## SERVICE BULLETIN

ENGINE - ANGLE GEARBOX ASSEMBLY - INTRODUCTION OF MODIFIED BRACKET SUPPORT - VSCF OIL COOLING TUBES - CATEGORY CODE 7 - MOD.ENG-72-0197

V2500-ENG-72-0197

Location of support bracket  
Fig.1

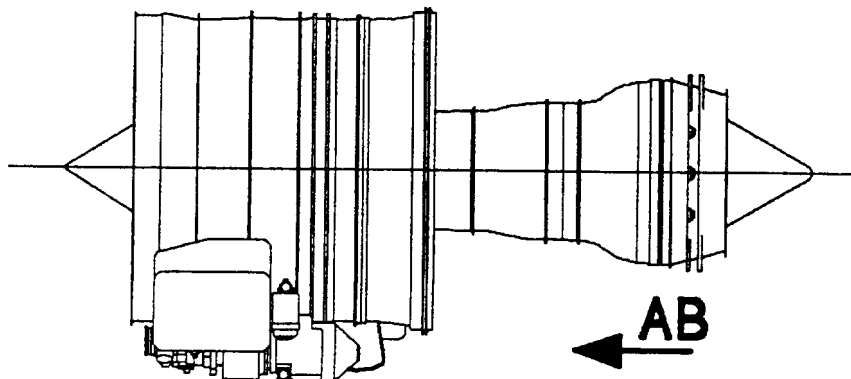
- (1) Find the 6A4949 bracket. Refer to Figures 1, 2 and 3.
- (2) Disassemble clipping point CP2354 sufficiently to allow the removal of 6A4949 bracket.
- (3) Remove the bracket retaining bolts (2 off) and washers (2 off) and remove the 6A4949 bracket.
- (4) Install the new 6A5903 bracket using the retaining bolts (2 off) and washers (2 off) previously removed in step (3).
- (5) Torque the retaining bolts (2 off) to 85 to 105 lbfin (10 to 12 Nm).
- (6) Install clipping point CP2354 using existing parts previously removed at step (2) and torque the bolt to 36 to 45 lbfin (4 to 5 Nm).

Views showing position of support bracket on angle gearbox  
Fig.2

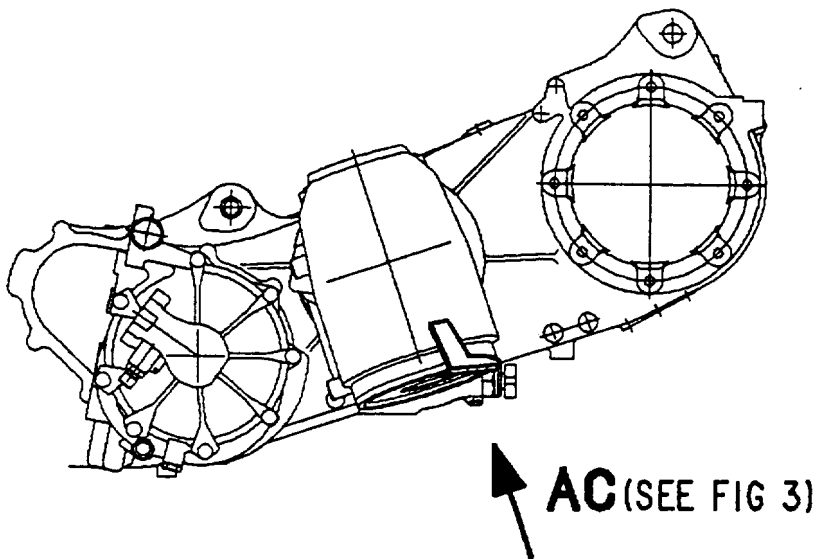
PART VIEW ON ARROW **AB**  
SHOWING POSITION OF SUPPORT  
BRACKET ON ANGLE GEARBOX

Part view on arrow AC (see Figure 2) - Before and after alteration  
Fig.3

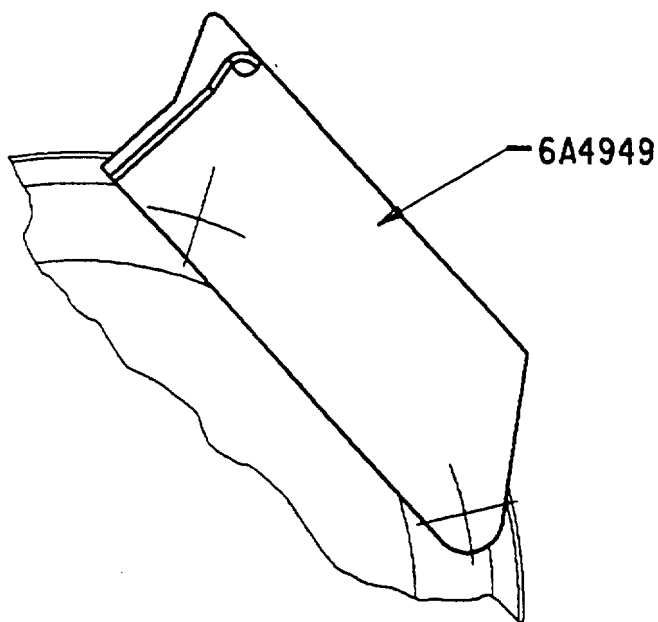
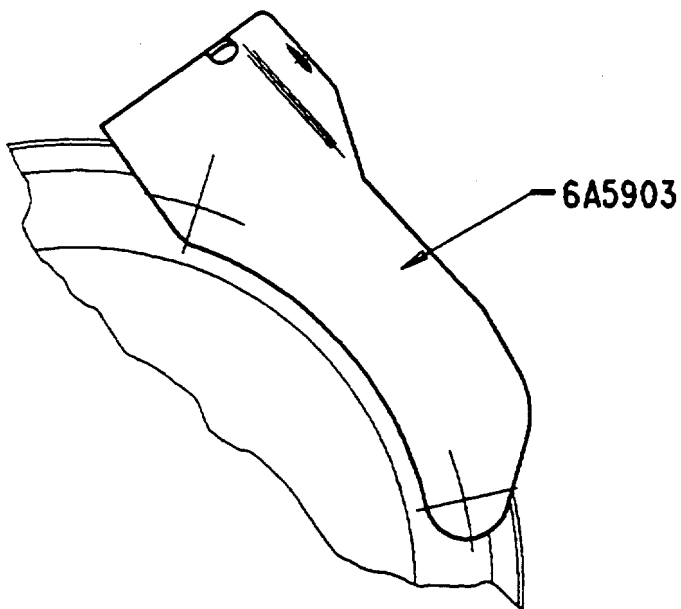
This Bulletin introduces a new bracket similar to the existing bracket except for a repositioned clipping hole and a redesigned stiffening web.

PART VIEW ON ARROW **AC** (SEE FIG 2)  
BEFORE ALTERATION

PART VIEW ON ARROW **AC** (SEE FIG 2)  
AFTER ALTERATION
